ADDENDUM NO. 002

RE: Bristol Community Health Center, Phase I Renovations
For Southwest Virginia Community Health Systems
T&L Project No. 16493

DATE: April 4, 2023

SKETCH ASK-07

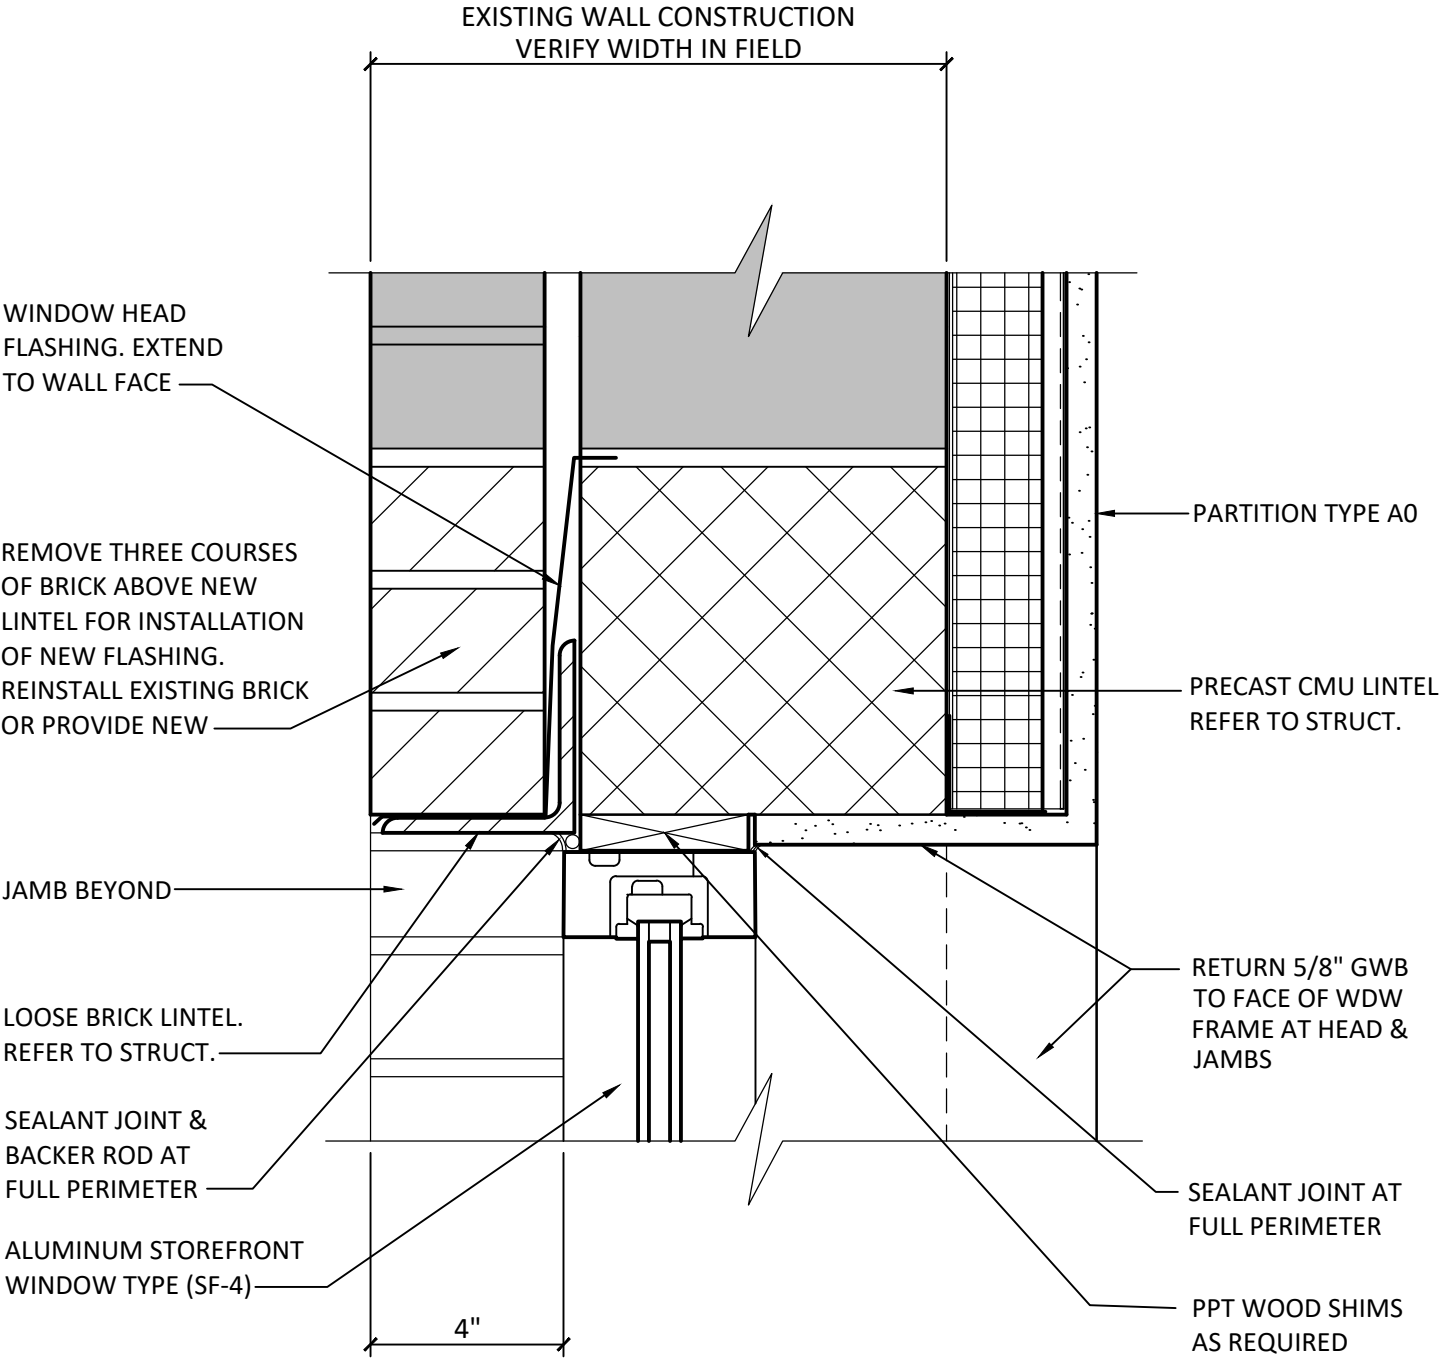
1. The elevator shaft foundation may be reduced to the out-to-out dimension in the plan east-west direction. Keep the foundation extension in the plan north-south direction. Refer to revised Structural drawings.
2. Refer to Sketches ASK-07 thru ASK-09 for details associated with Aluminum Storefront Elevation (SF-4) located in existing exterior wall. Coordinate these sketches with revisions noted below and on enclosed Structural drawing S001.

Sheet No.
A101

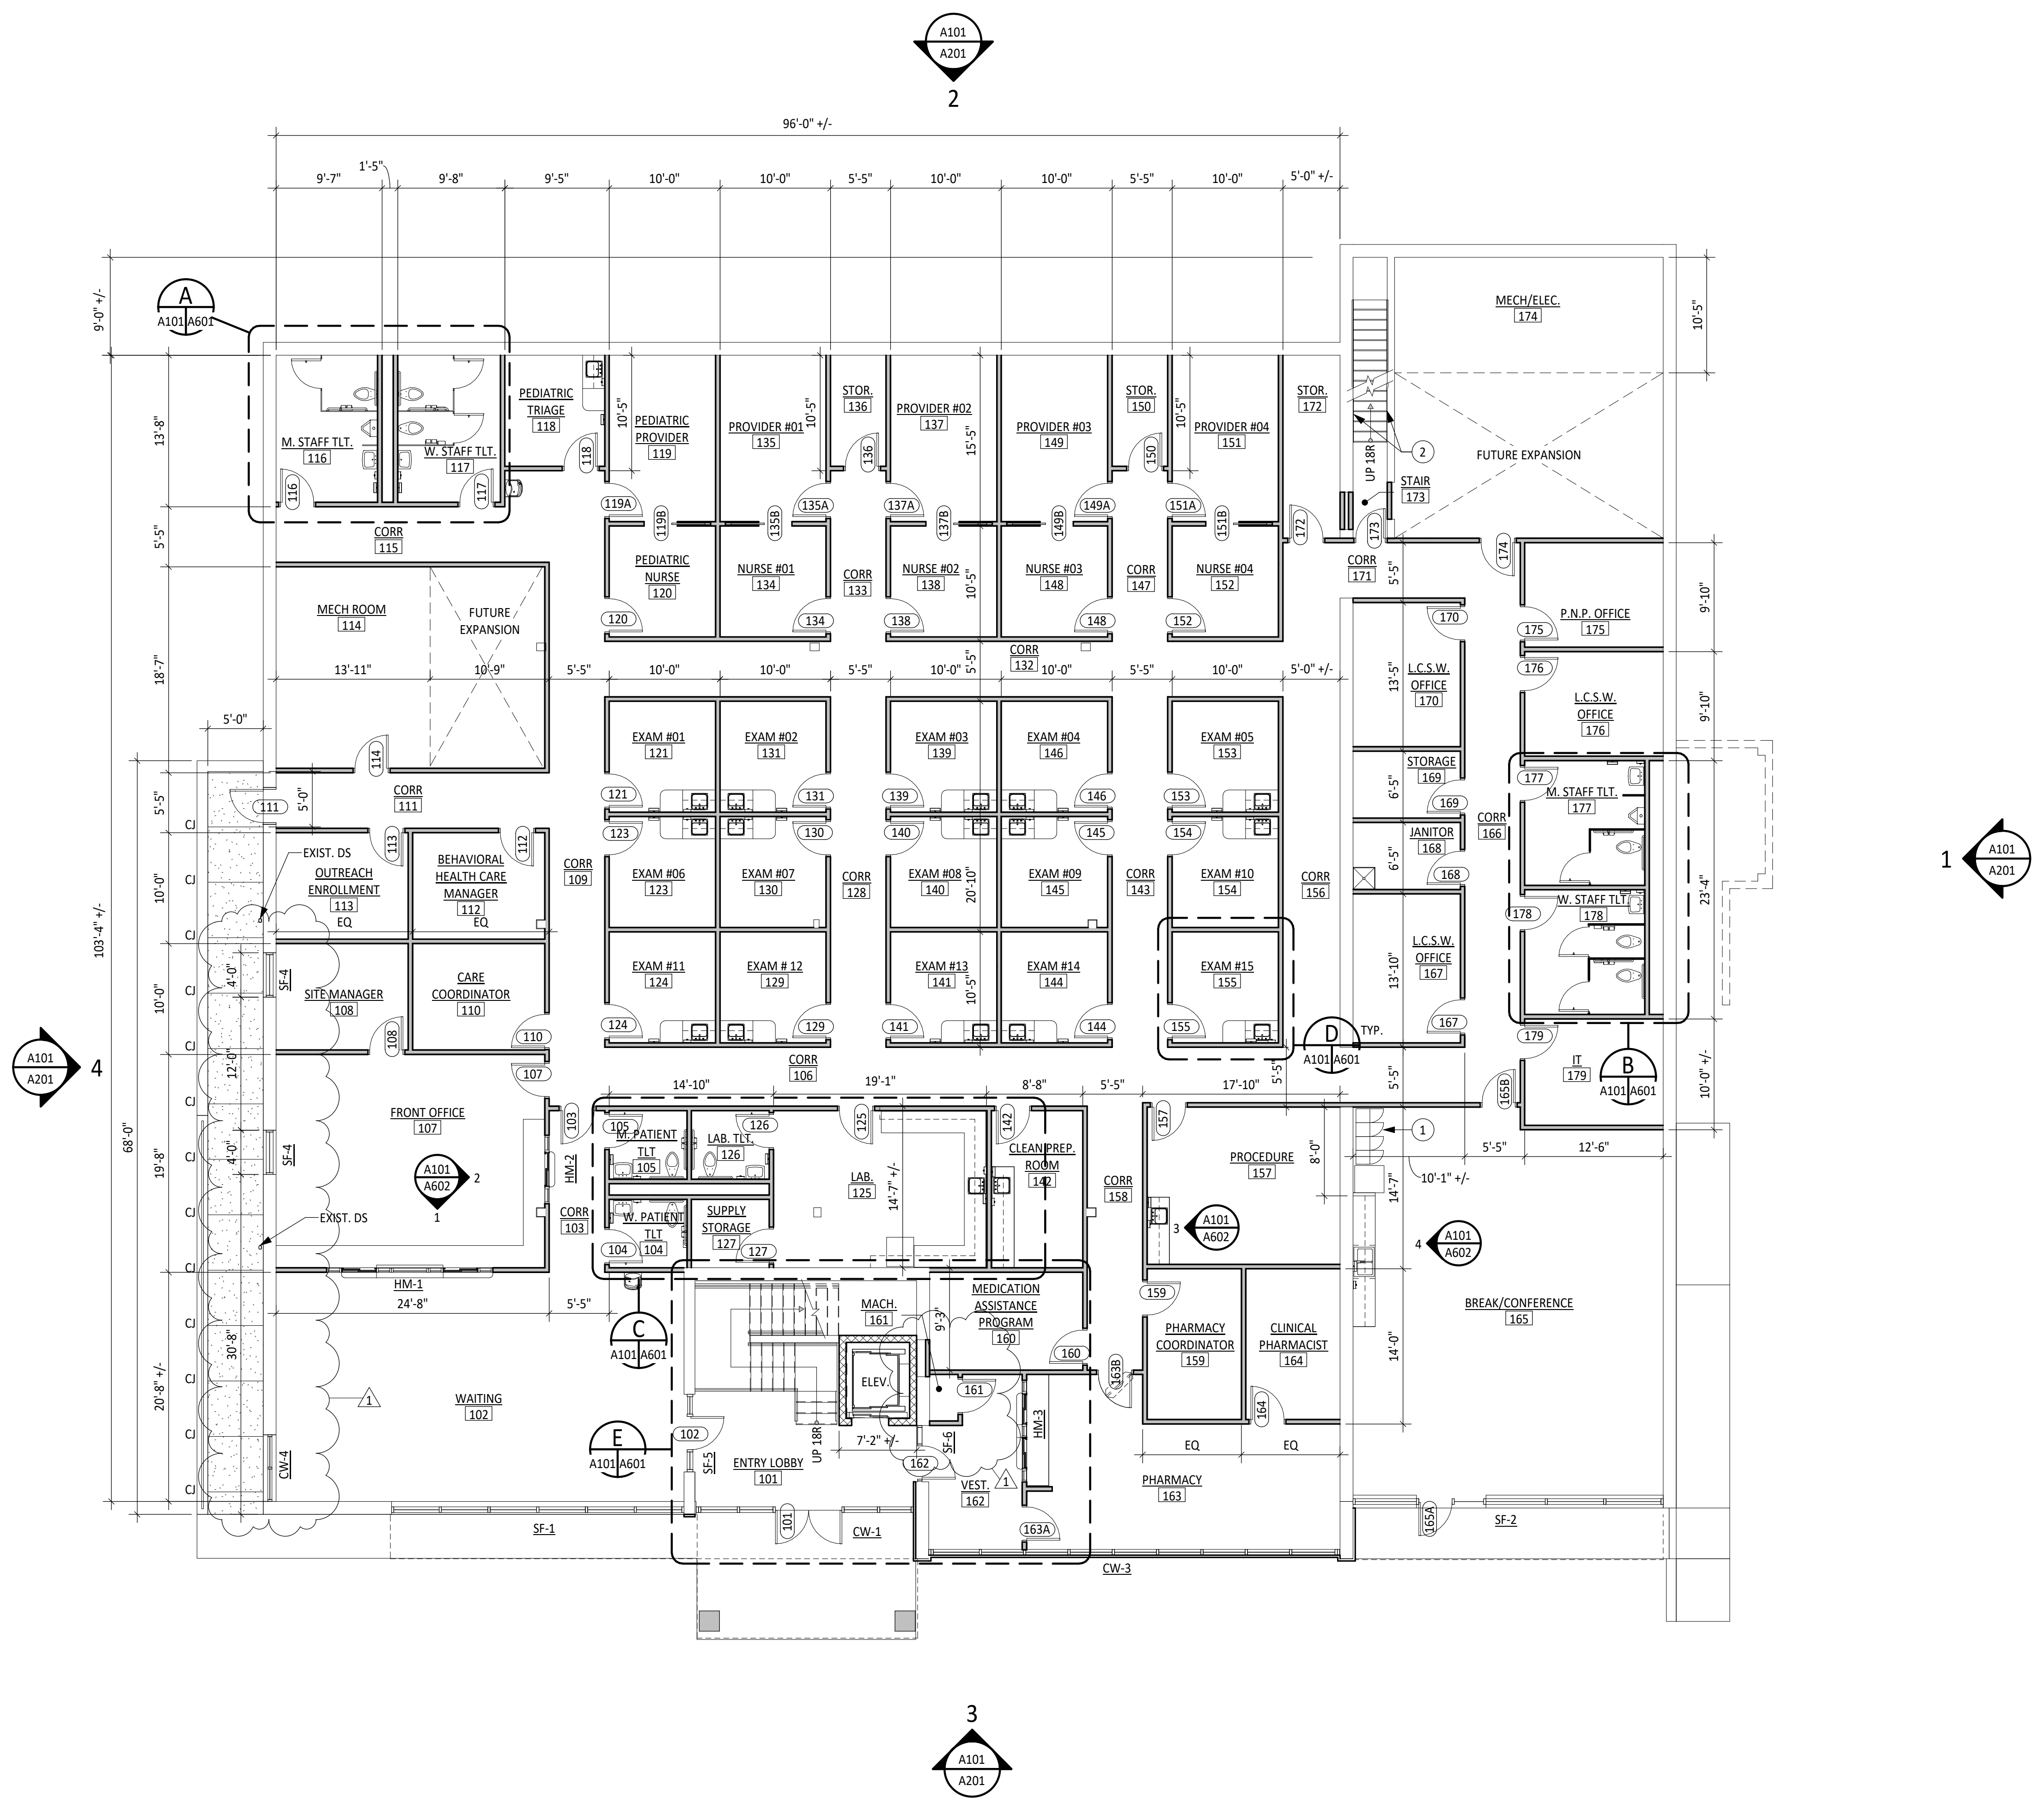
1. Refer to Drawing AD101 for clarification of selective demolition extent at elevator location.
2. Refer to Drawing A101 for revised number and spacing of Aluminum Storefront Elevation (SF-4), and relocation of elevator machine room
3. Refer to Drawing A102 for clarification of existing versus new work at new elevator location.
